UNITED STATES PATENT AND TRADEMARK OFFICE

APPLICATION NO.	FILING DATE	FIRST NAMED INVENTOR	ATTORNEY DOCKET NO.	CONFIRMATION NO.
10/572,863	03/22/2006	Antonio Silvio Sampaio Doria	2918.00002	7295
10/534 7590 04/10/2009 BLISS MCGLYNN, P.C. 2075 WEST BIG BEAVER ROAD SUITE 600 TROY, MI 48084				
EXAMINER VARNUM, RYAN A				
ART UNIT		PAPER NUMBER		
4118				
MAIL DATE		DELIVERY MODE		
04/10/2009		PAPER

Office Action Summary**Application No.**

DETAILED ACTION

Annotated Partial Fig. 1

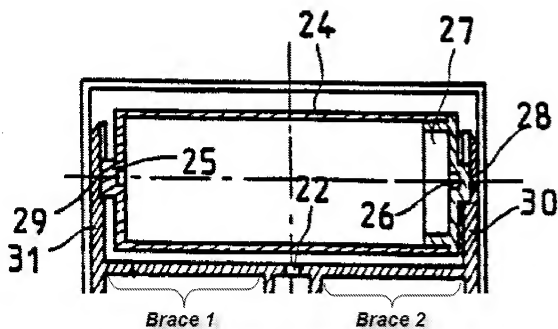
13. Claims 1, 4, 6, 10 and 13 are rejected under 35 U.S.C. 102(b) as being anticipated by Lucas (US Patent 5,026,193).
14. In re Claim 1, Lucas discloses a cylindrical applicator for dispensing cosmetic compositions in the form of liquid, cream, gel, and others, onto the human skin, adaptable to various kinds and shapes of packages (Column 1, Lines 60-61), comprising: a cylinder 24 (Fig. 1; Column 2, Lines 36-37), an element bounded by an oblong round wall, such as a tube, and two circular, flat, equal and parallel ends, ("cylinder"; Fig. 1; Column 2, Lines 36-37); and a seat 16 ("distributor"; Fig.'s 1-2;

Column 2, Lines 10-12), which comprises: two semicircular guides ("Guides"; See Annotated Partial Fig. 2 below), directed toward the inside, two support circles 30/31 ("flanges"; Fig.'s 1-2; Column 2, Line 43) at its ends formed by disks of two circumferences, being the upper disk smaller than the lower one ("Upper Disk", and "Lower Disk"; See Annotated Partial Fig. 2 below), with a smaller radius ("R1" and "R2"; See Annotated Partial Fig. 2 below), two inferior braces ("Braces 1/2"; See Annotated Partial Fig. 1 below), which define the length of the distribution opening 22 (Fig.'s 1-2; Column 2, Lines 21-22), being said cylinder encased in said seat by being pressed into it ("engaged via a resilient deformation"; Column 2, Lines 42-43; it being understood that such deformation is achieved by pressing the cylinder with pins, into the depression to cause such resilient deformation), where said cylinder is supported mainly by the semicircular guides (Fig.'s 1-2) and is free to roll.

Annotated Partial Fig. 2

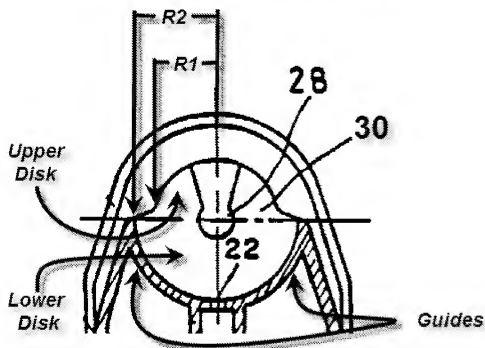
15. In re Claim 4, Lucas further discloses the seat 16 (Fig.'s 1-2) is a distinct element from the main body of the package 1 ("container"; Fig. 1; Column 1, Line 60), molded separately (Column 1, Lines 19-22), made of a resilient material (Column 2, Line 42), which seat fits within the mouth of the main body of the package in fluid-tight connection (Column 1, Lines 14-18).

16. In re Claim 6, Lucas further discloses the seat 16 (Fig.'s 1-2) is provided with a gating 6 ("cylindrical socket"; fig.'s 1-2; Column 1, Lines 67-68), at its lower part, with holes 8 (Fig. 2; Column 2, Line 1) that control the flow of the product (Column 2, Lines 52-58).
